AG-MI-2013-12-B-EN – Replacement of Oil Sump Hose

Category B

Inspect the configuration state of 'oil hose engine sump' and replace with steel braided hose if necessary

Fig. 2 – Rubber ,oil hose engine sump' (to be replaced/old)

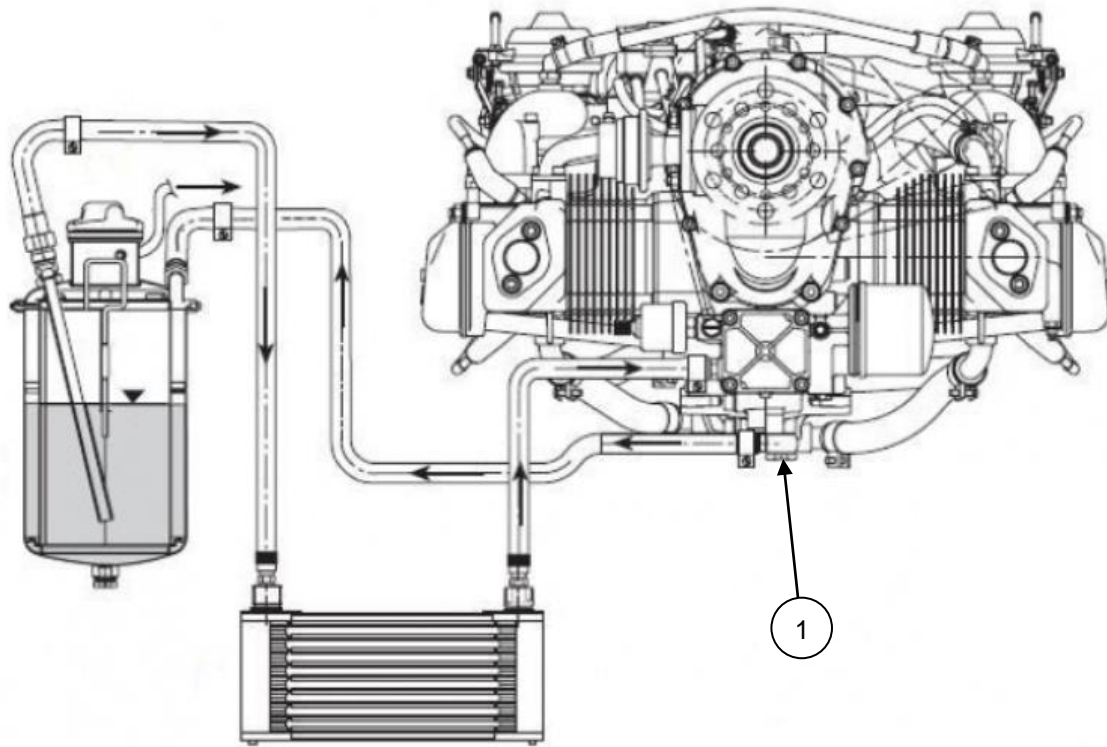
- 1 Demount cowlings according to 52-00-00 4-1. Inspection of configuration state. If rubber oil sump hose (Fig. 2) is mounted, perform steps 2-8.
- 2 Remove oil tank cover. Turn propeller by hand in direction of engine rotation (i.f.d. to the left) until a "gurgling"-sound is hearable in the oil tank. Close oil tank cover.
- 3 Snap off and remove cable ties on oil sump hose.
- 4 Remove wire lock of hollow screw/oil sump hose (Fig. 1-1). Unscrew hollow screw. Dispose of copper seal rings. Catch leaking oil residuals.
- 5 Unscrew oil sump hose from oil tank (in-side). Remove oil sump hose.
- 6 Mount steel braided oil sump hose in reverse order 5-2. Use new copper seal rings! Use standard torques for tightening.
- 7 Perform test run. Inspect for tightness of the lubrication system!
- 8 Mount cowlings according to 52-00-00 4-1.

Fig. Pos.	Description	PC PIT	Remark
3	Oil hose engine sump 912	L1 C.OL201	Calidus Rotax 912
3	Oil hose engine sump 914	L1 C.OL301	Calidus Rotax 914
3	Feeding Pipe Oil Sump	L1 V.OL10.02	Cavalon Rotax 912 and 914

Fig. 3 – Steel braided oil hose (new)
